Addendum No. 2
BL049-24
Wolf Lake (Y-14) Dam Rehabilitation

The following addition/changes modify the Bid No. BL049-24 "Wolf Lake (Y-14) Dam Rehabilitation Contract Documents, dated April 2024, as first advertised on April 03, 2024.

CP-101

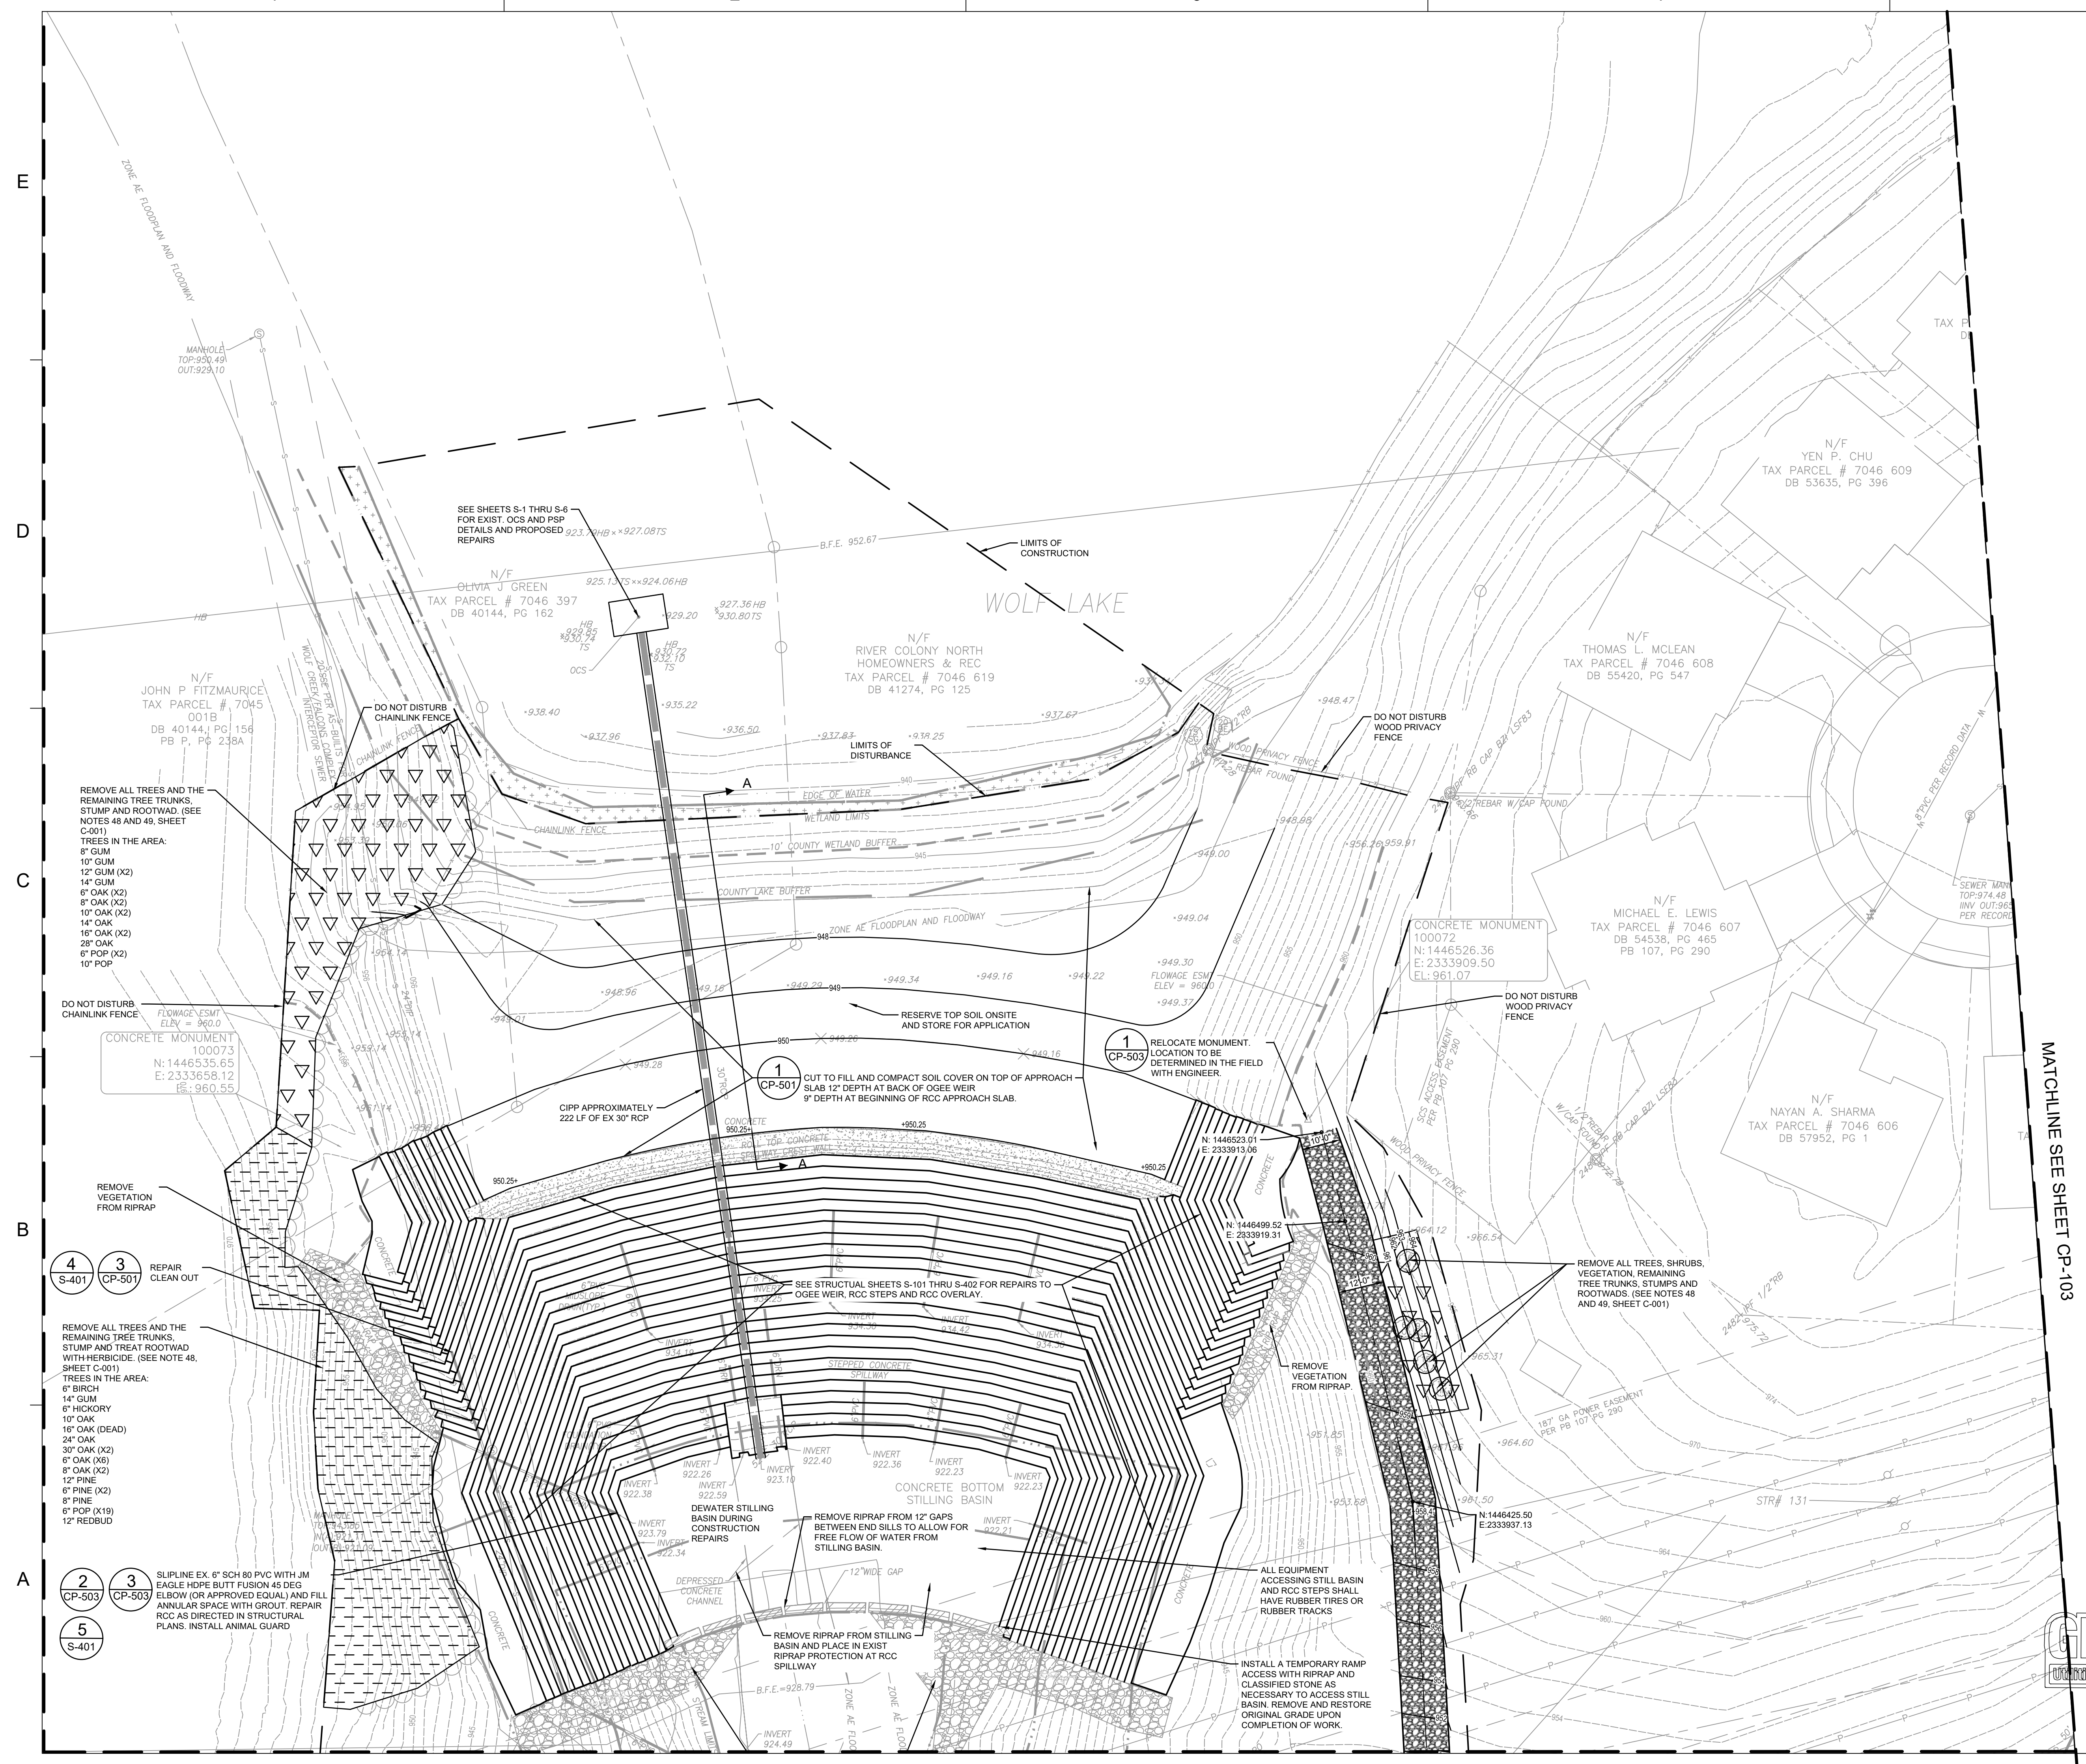
Q4. "Drawing CP-101 appears to show as-built elevations around the OCS's, but these elevations appear to be higher than the OCS invert. Is there any anticipated excavation or demucking around the OCS's that will be required? If so, please clarify and provide limits of excavation/demucking and consider adding a unit price item to handle this work as the quantity is unknown. Can the material be left onsite and not hauled off?"

- Q10. Drawing CP-101 has a note stating “REMOVE RIPRAP FROM STILLING BASIN AND PLACE IN EXIST RIPRAP PROTECTION AT RCC SPILLWAY”. The stilling basin appears to always be flooded and no way to see the concrete bottom of the stilling basin. Please clarify how much rip rap is expected to be removed from the stilling basin, as the drawings don’t indicate any rip rap in the stilling basin. Also from the site visit the rip rap that is partially visible appears to be fairly dirty, please confirm the rip rap is not to be cleaned, and only removed and placed in the designated areas. If it is now your intent to clean the rip rap please clarify the desired cleaning procedure and expectations.**

A4. Localized excavation/demucking around the OCS is anticipated. Drawing CP-101 and CP-102 have been reissued to present additional top of sediment and hard bottom elevations.

- R1. Construction Plan Sheets CP-101 through CP-102:** Replace Sheets CP-101 through CP-102 dated 2/14/2024 in the Construction Plans with the attached revised Sheets CP-101 through CP-102 dated 5/9/2024. See A4.

EC-101

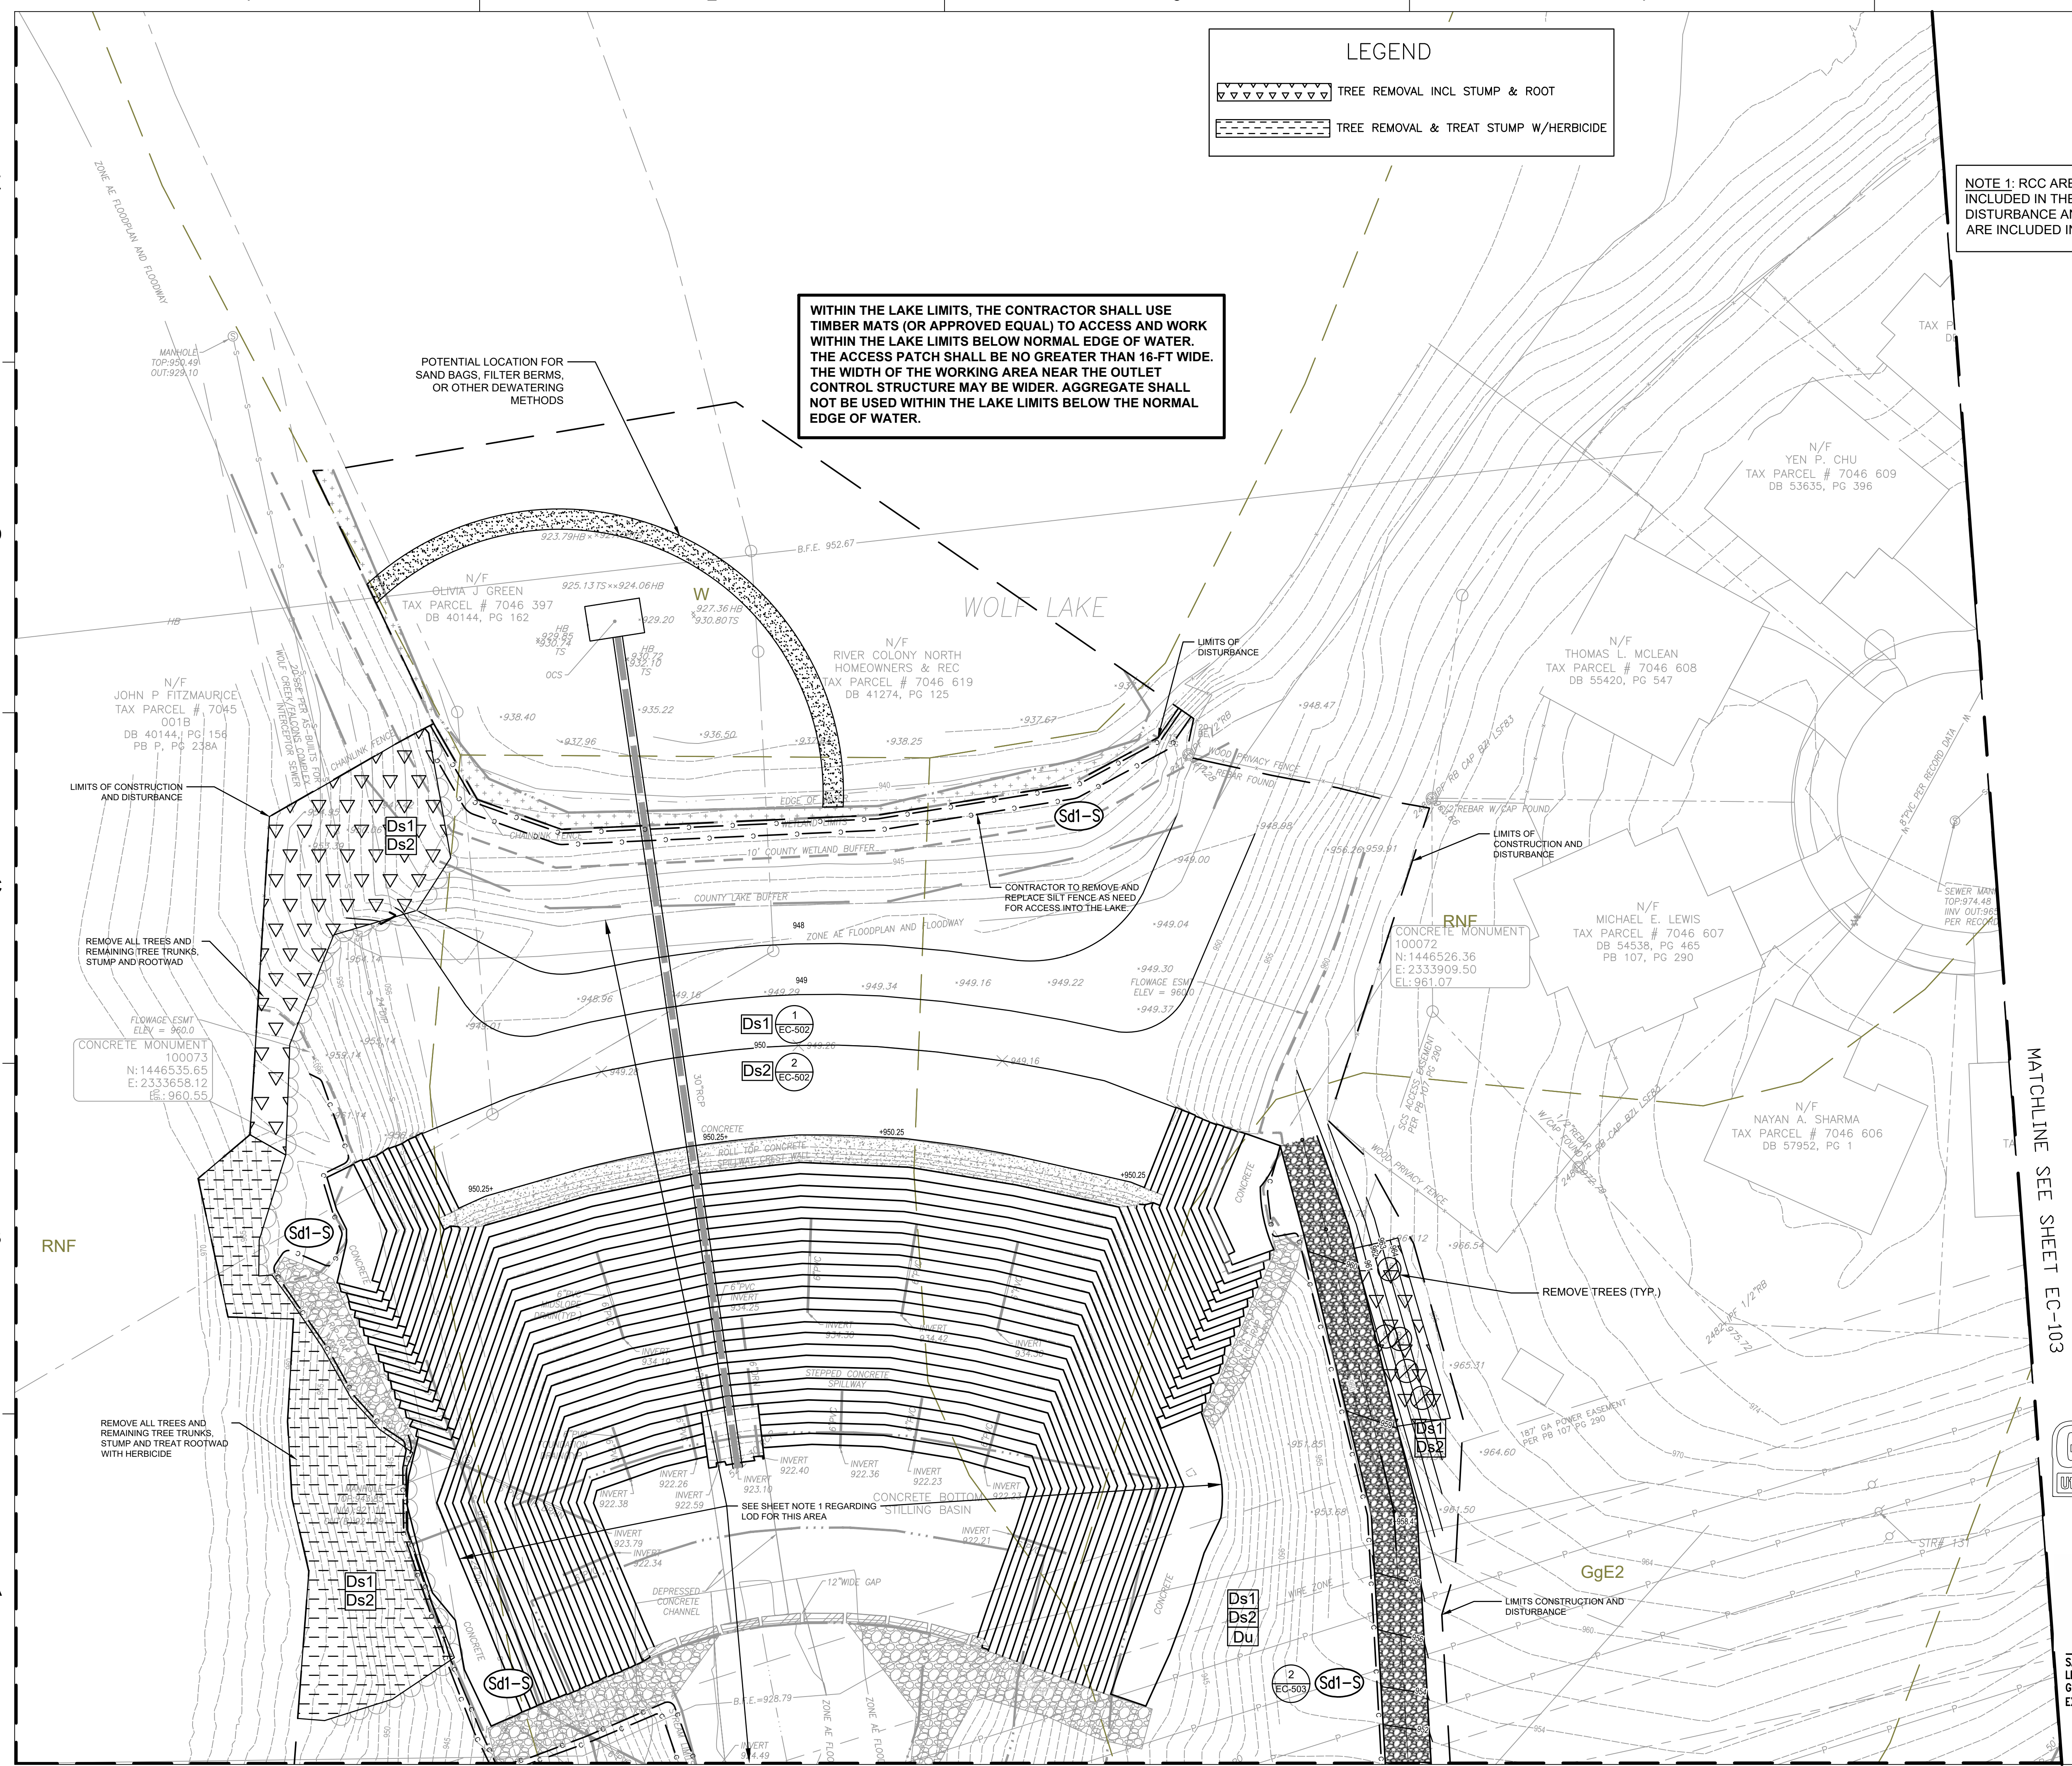
Q5. Drawings EC-101 and EC-102 show different symbols (triangles or dashes) around the site for Ds1 & Ds2 areas. Please clarify what the different symbols signify.

A5. A legend has been added to EC-101 and EC-102 to provide clarification.

- R2. Construction Plan Sheets EC-101 through EC-102:** Replace Sheets EC-101 through EC-102 dated 2/14/2024 in the Construction Plans with the attached revised Sheets EC-101 through EC-102 dated 5/9/2024. See A5.
